SERVICE BULLETIN

_{N°} 139-778

ATA 55 - TAIL PLANE ROD ASSY INSTALLATION INSPECTION

Leonardo Helicopters issued this Service Bulletin as consequence of some in-service reports and a Quality Alert from MAG: it has been identified a batch of potentially non-conformant tail plane rod assy P/N 3G5510A08931 because of the incorrect placement of the "INBOARD" decal P/N 3G1120A13951.

Figure 1

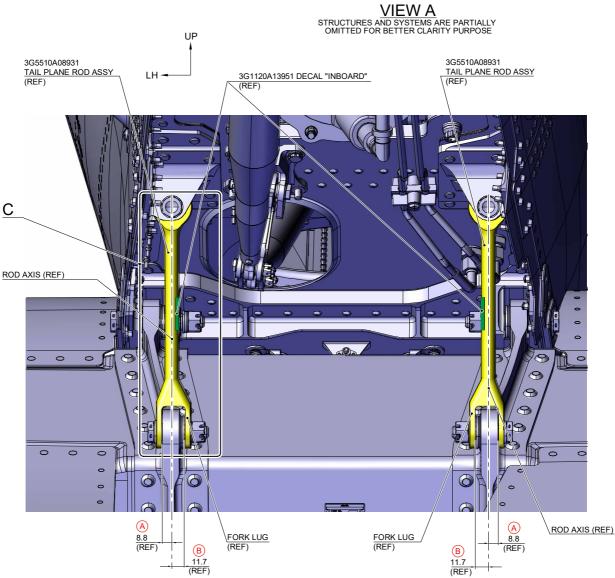
- 1. In accordance with AMP DM 39-A-00-20-00-00A-120A-A, prepare the helicopter on ground for a safe maintenance. Disconnect the battery, all electrical power sources and/or the external power supply.
- 2. In accordance with AMP DM 39-A-06-41-00-00A-010A-A and with reference to Figure 1 View A, remove the access panels 360DL and 360CL to gain access to the area affected by the inspection.
- 3. With reference to Figure 1 View B, Figure 2 and Figure 3, check if the tail plane rod assy P/N 3G5510A08931 is installed in the correct position, as described in the following procedure:

- 11. Record for compliance with this Service Bulletin on the Log Card of the tail plane rod assy P/N 3G5510A08931.
- 12. In accordance with AMP DM 39-A-06-41-00-00A-010A-A and with reference to Figure 1 View A re-install the access panels 360DL and 360CL previously removed.
- 13. Return the helicopter to flight configuration and record for compliance with this Service Bulletin on the helicopter logbook.
- 14. Gain access to My Communications section on <u>Leonardo Customer Portal</u> and compile the "Service Technical Bulletin Application".

Figure 2

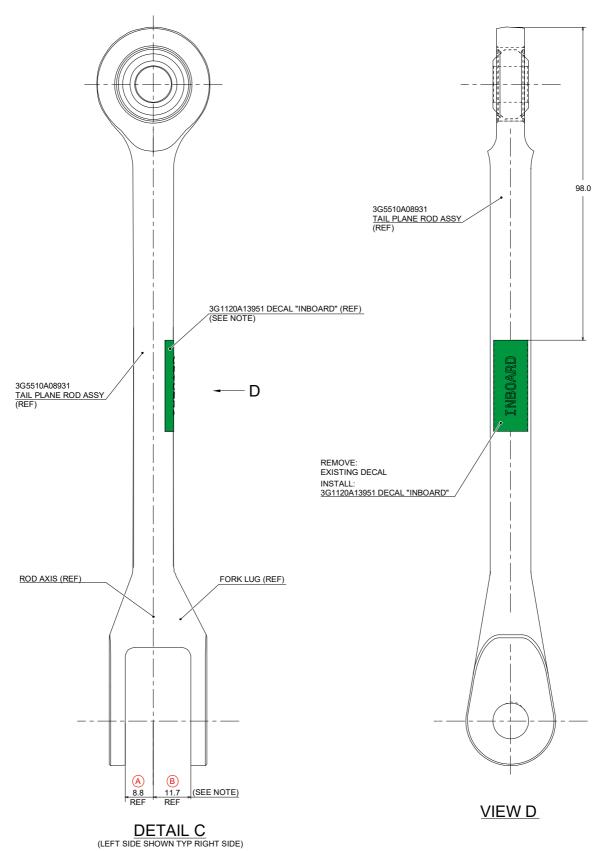
The decal "INBOARD" P/N 3G1120A13951 must be installed on the same side where fork lug is located 11.7 mm from rod axis (Ref. Figure 2 Detail C).

- 5. In accordance with Figure 2, check if the decal "INBOARD" P/N 3G1120A13951 is installed in the correct position.
 - In case of not compliant installation, compile and send the Inspection Report Form in Figure 4 and proceed with step 7, otherwise proceed with step 11.
- 6. In accordance with AMP DM 39-C-55-11-02-00A-520A-A (LH side) or DM 39-C-55-11-03-00A-520A-A (RH side) and with reference to Figure 1, remove the left or right tail plane rod assy P/N 3G5510A08931 from the helicopter, as necessary.

8. In accordance with AMP DM 39-A-11-00-01-00A-520A-A and with reference to Figure 2 View D, remove the existing decal from the wrong position on the tail plane rod assy P/N 3G5510A08931.

Install the decal "INBOARD" P/N 3G1120A13951 taking care to bond it on the same side where fork lug is located 11.7 mm from rod axis (Ref. Figure 2 Detail C).

- 9. In accordance with AMP DM 39-A-11-00-01-00A-720A-A and with reference to Figure 2, install the new decal "INBOARD" P/N 3G1120A13951 to the indicated position on the tail plane rod assy P/N 3G5510A08931.
- 10. In accordance with AMP DM 39-C-55-11-02-00A-720A-A (LH side) or DM 39-C-55-11-03-00A-720A-A (RH side) and with reference to Figure 1, install the left or right tail plane rod assy P/N 3G5510A08931 on the helicopter, as necessary.

NOTE:
INSTALL DECAL INBOARD TAKING CARE TO BOND IT ON THE SAME SIDE WHERE FORK LUG IS LOCATED 11.7 MM FROM ROD AXIS.

Figure 3

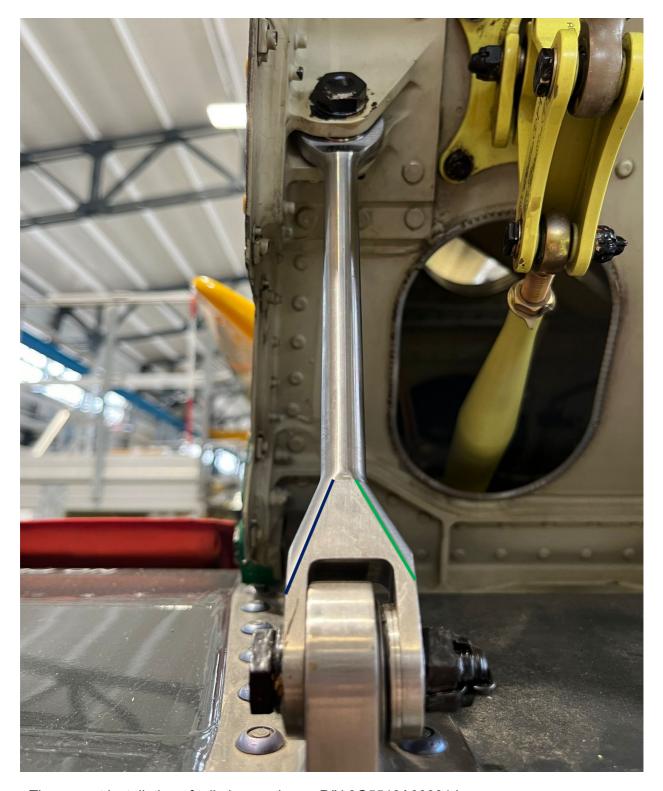
As shown in Figure 3, the correct installation of the tail plane rod assy P/N 3G5510A08931 has:

- the longer highlighted side of the fork end (blue)
 on the OUTBOARD side of the installation;
- the shorter highlighted side of the fork end (green) on the INBOARD side of the installation.
- 3.1 Using a caliper gauge, take the dimension "A" and "B" on the fork lug of the tail plane rod assy P/N 3G5510A08931 and verify that the larger dimension is on the inboard side of the tail plane rod assy installation.
- 3.2 In case of findings, compile and send the Inspection Report Form in Figure 4 and proceed with step 6; otherwise proceed with the following step.
- 4. In accordance with Figure 1 View B, check if the decal "INBOARD" P/N 3G1120A13951 facing the inboard side of the helicopter.
 - In case of not compliant decal installation, compile and send the Inspection Report Form in Figure 4 and proceed with step 6; otherwise proceed with step 11.

The correct installation of tail plane rod assy P/N 3G5510A08931 has:

- the longer highlighted side of the fork end (blue) on the **OUTBOARD** side of the installation;
- the shorter highlighted side of the fork end (green) on the INBOARD side of the installation.
